HISTORIC DISTRICT COMMISSION NOTICE OF DENIAL

Application Number: HDC2025-00753

PROJECT ADDRESS: 1616 W. Chicago Blvd Detroit, MI

HISTORIC DISTRICT: Boston-Edison

SITE PLAN SCALE 1"=20'-0"
 1616 W. CHICAGO BLVD. DETROIT MI. 48206

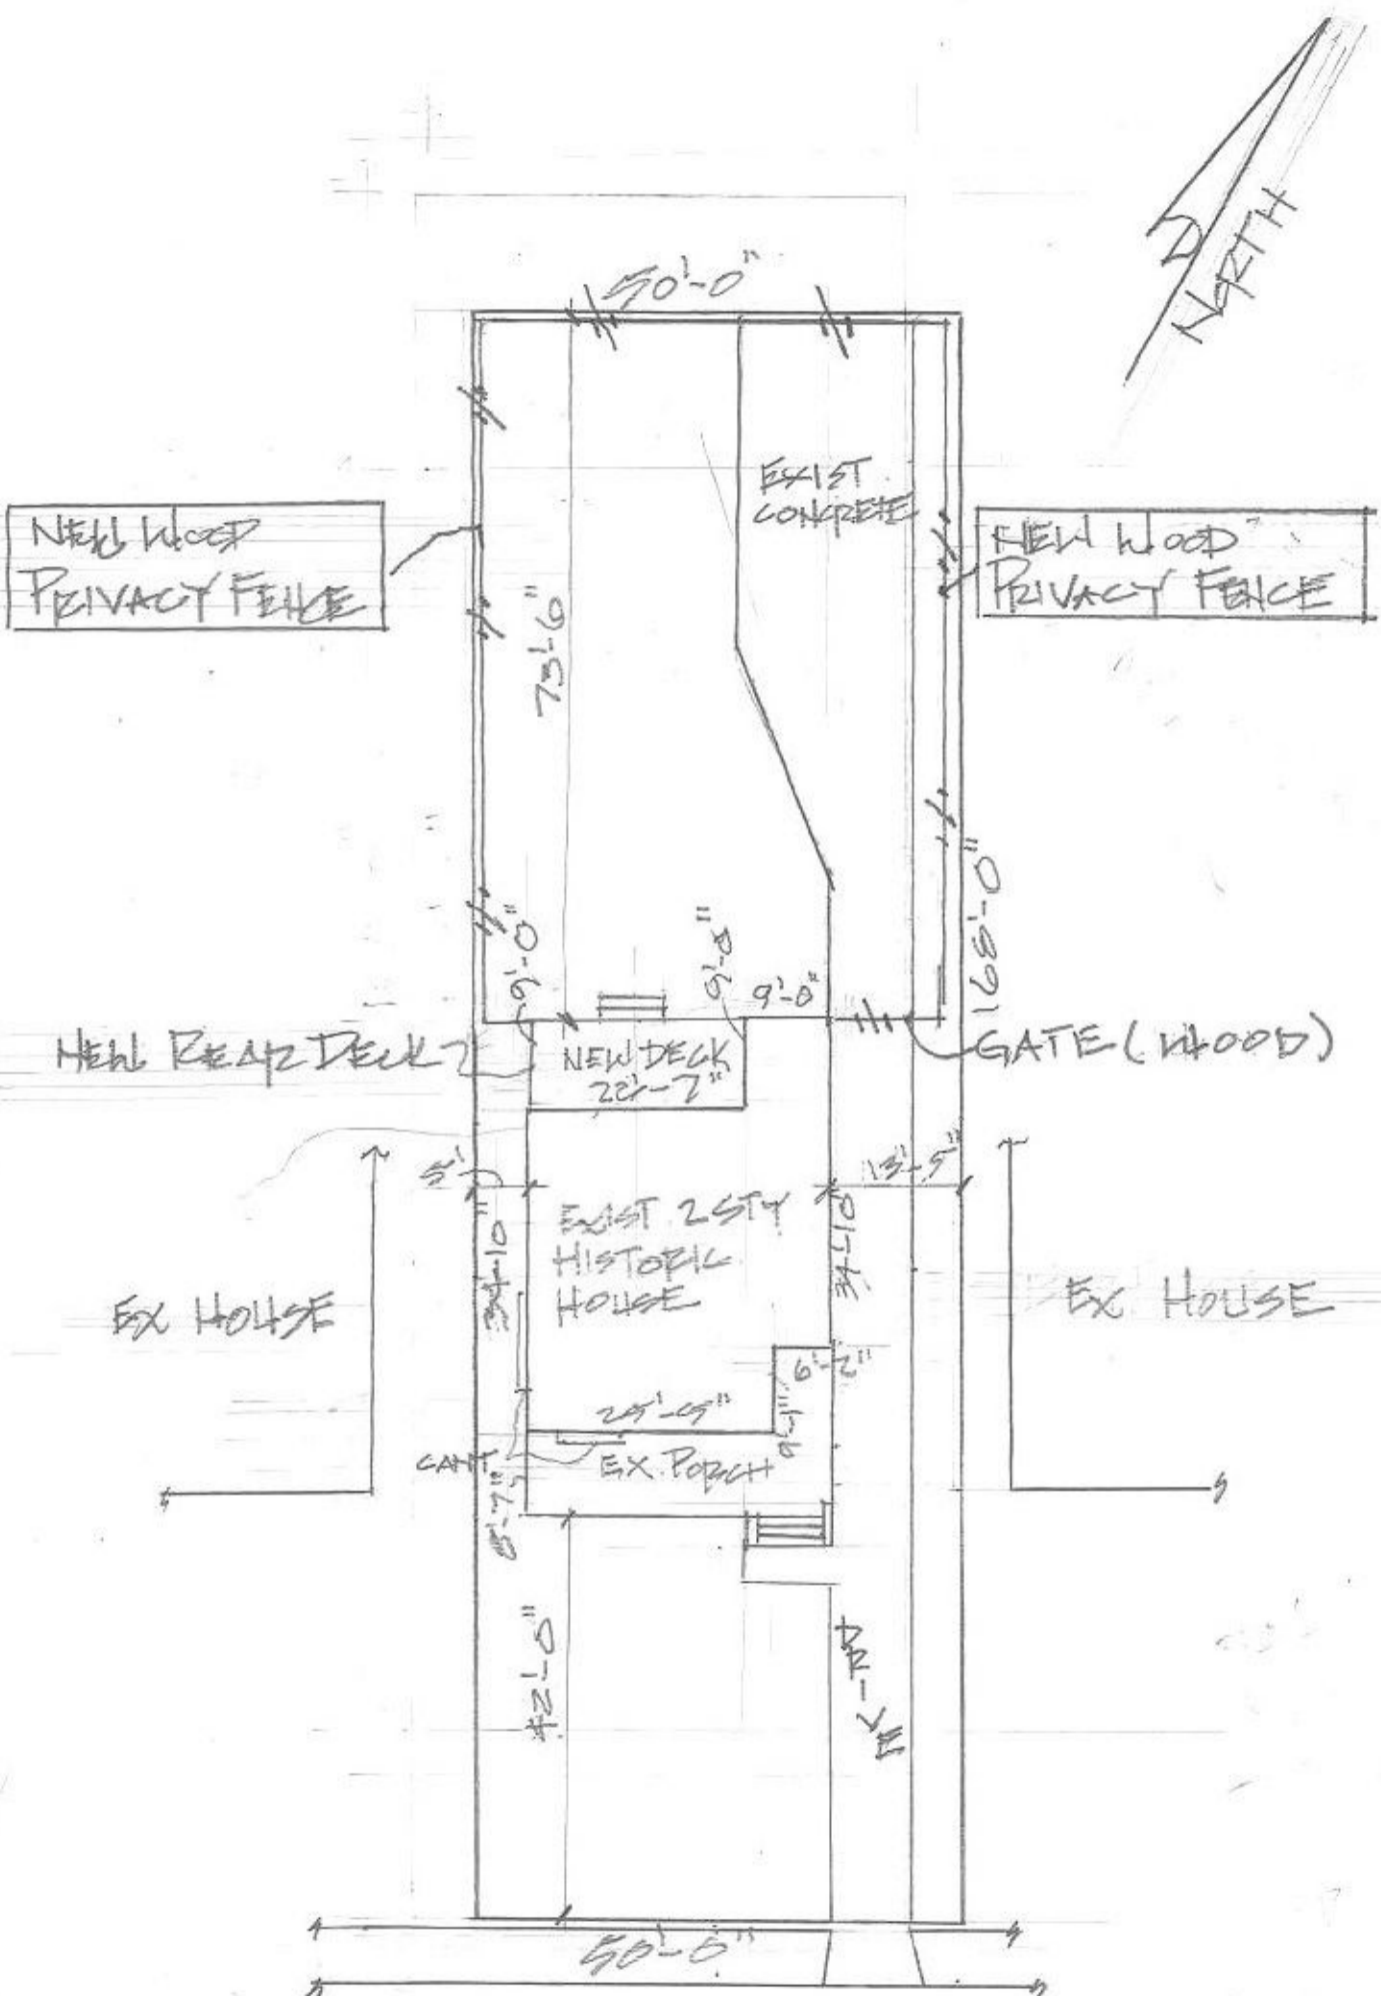
- A site plan with dimensions (this can be hand drawn) of location of proposed fence/any gates
- Finish (NOTE: treated fences need to be painted or stained opaque after a year)

I have provided additional photos of the exterior of the house. We are no longer going to change any of the existing entry doors. The existing front porch slab will not be removed. We will fill in the cracks and repair the broken areas on the front of the slab. We have added a Site plan and elevations of the proposed rear deck. The site plan also shows the location of the proposed rear wood privacy fence. We will paint it within 1 year. We will not be doing anything to the dormers. I have found and attached pictures of the 2 story rear dormer before it was demolished. The siding appears to have been a stucco type covering. I'm sorry. I don't have any specifications of the siding that was on the demolished 2 story rear wing.
